Old Street

Three Tier Assessments

Tier 3 – 26.06.19

All Inclusive Cycling
and Walking at
Roadworks Report

Options

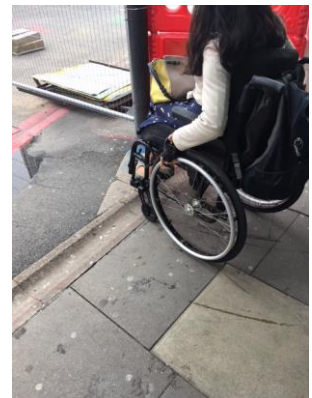
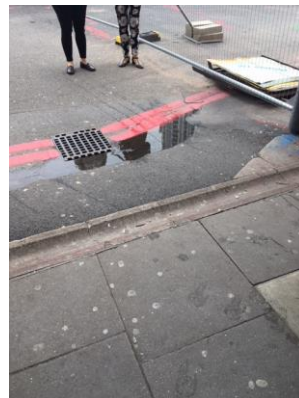
- Wheelchair user was not confident to use the diversion route as it was using the road and she may not be able to get back on the footway
- Visually impaired person mentioned ramp was not clear and the red and white signs blend in with red and white background.
- Investigate signage messages and how to be clear e.g. larger with more contrast and diversion signs stating 'accessible ramps each end'
- Wheelchair user found the gradient too steep and the double red lines uncomfortable to negotiate.

1. Extend ramp to cover double red which will supply gentle slope. Put water filled to the side to avoid access issues
2. Remove asphalt and replace with NAL ramp as per below.
